R44 SERVICE BULLETIN SB-90

SUBJECT: Revised Instrument Marking

ROTORCRAFT AFFECTED: R44 Helicopters S/N 0004 thru 2449 and R44 II Helicopters 10001 thru 14026.

FIGURE 1

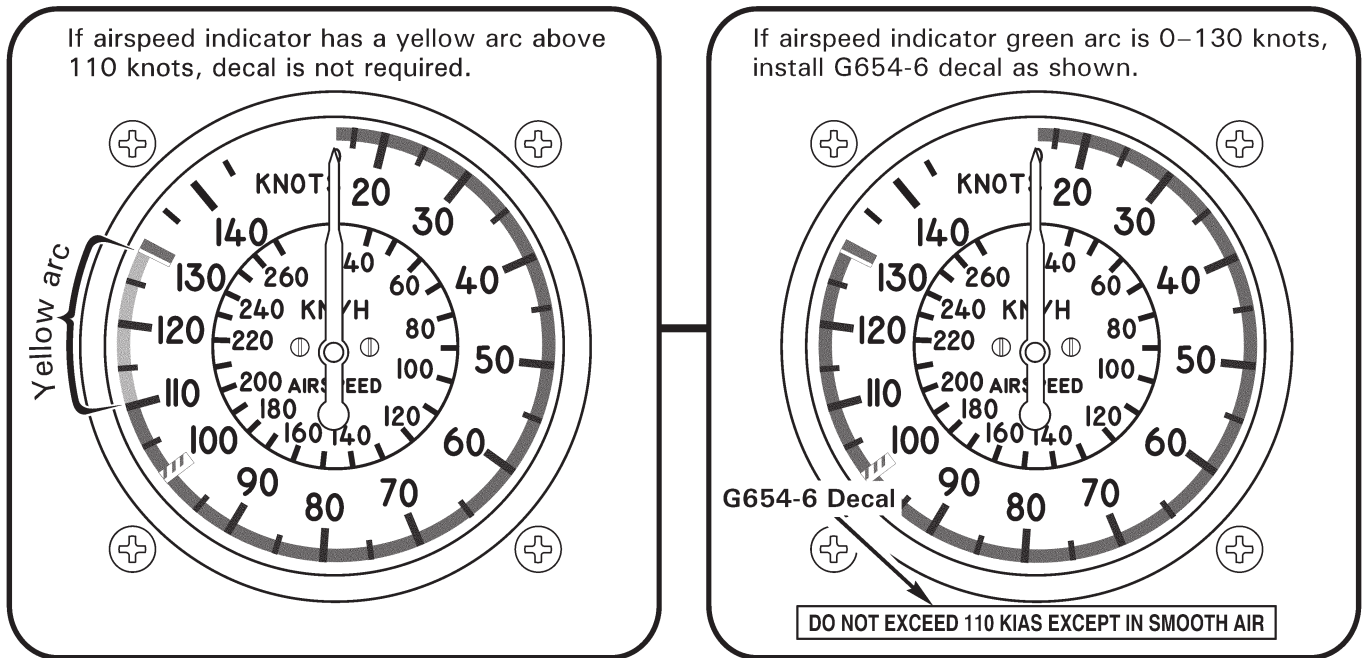
BACKGROUND: Pilot's Operating Handbook (POH) revision dated 21 October 2016 adds a yellow arc above 110 knots to the airspeed indicator. This bulletin requires installing a decal (placard) specifying revised precautionary range adjacent to earlier instruments and revising, if installed, airspeed indication of Aspen or Garmin electronic flight display.

1. If installed airspeed indicator green arc is 0–130 knots (or 0–241 km/h) install G654-6 decal as shown. If indicator has a yellow arc above 110 knots (or 204 km/h), decal is not required.
2. If electronic flight display is installed, have applicable authorized Aspen (www.aspenavionics.com) or Garmin (www.garmin.com) facility revise airspeed indication to match 19 October 2016 POH revision.
